Access Compliance Report

(Curb Ramps)

Intersection ID: 5588	Main Street: CARVER_BV	Cross Street: ROCKWELL_BV	Location: NE
ADA ID: 06B9FA0A23D7	Ramp Type: Para	Initial Pass/Fail: Fail	Overall Compliance: No
Codes/Mitigation Info/Possible Solution			Severity Score: 25
			Field Measurements/Component Compliance

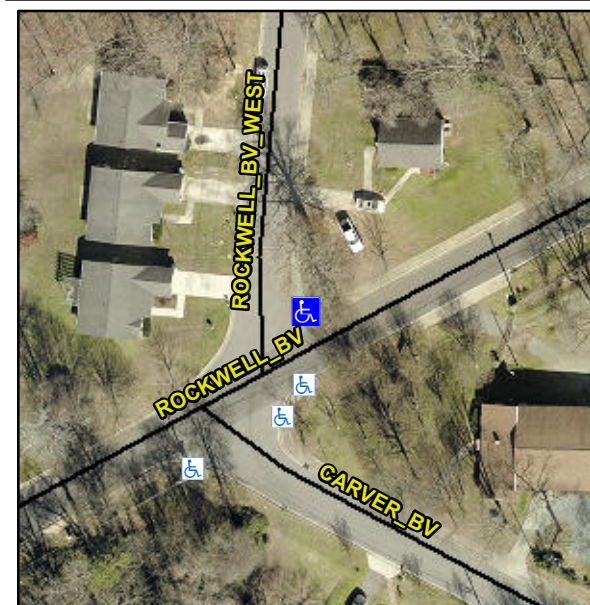
R304.5.1, R304.3.2

Compliance	Description	Data	Compliance	Description	Data
N/A	Ramp Length LT (in)	N/A	N/A	Ramp Length RT (in)	44.0
N/A	Ramp Width LT (in)	N/A	No	Ramp Width RT (in)	36.0
N/A	Ramp Slope LT (%)	N/A	No	Ramp Slope RT (%)	14.7
N/A	Ramp XSlope LT (%)	N/A	Yes	Ramp XSlope RT (%)	1.6
N/A	Landing Length (in)	N/A	N/A	DWS Provided?	N/A
N/A	Landing Width (in)	N/A	N/A	DWS Contrast?	N/A
N/A	Landing Slope (%)	N/A	N/A	DWS Length (in)	N/A
N/A	Landing X Slope (%)	N/A	N/A	DWS Full Width?	N/A
N/A	Landing Curb? (Y/N)	N/A	N/A	DWS Offset (in)	N/A
N/A	Shared Landing?	N/A			
N/A	Gutter Ponding?	N/A	N/A	Gutter Slope (%)	N/A
N/A	Gutter Lip Ht (in)	N/A	N/A	Gutter X Slope (%)	N/A
N/A	Painted X Walk1?	No	N/A	Painted X Walk2?	N/A
	X Walk 1 Direction	To S		X Walk 2 Direction	N/A
N/A	X Walk 1 Width (in)	N/A	N/A	X Walk 2 Width (in)	N/A
	X Walk 1 Slope (%)	2.0		X Walk 2 Slope (%)	N/A
	X Walk 1 X Slope (%)	2.6		X Walk 2 X Slope (%)	N/A
N/A	Ramp inside XWalk1?	N/A	N/A	Ramp inside XWalk2?	N/A

Remove & Replace Entire Ramp.
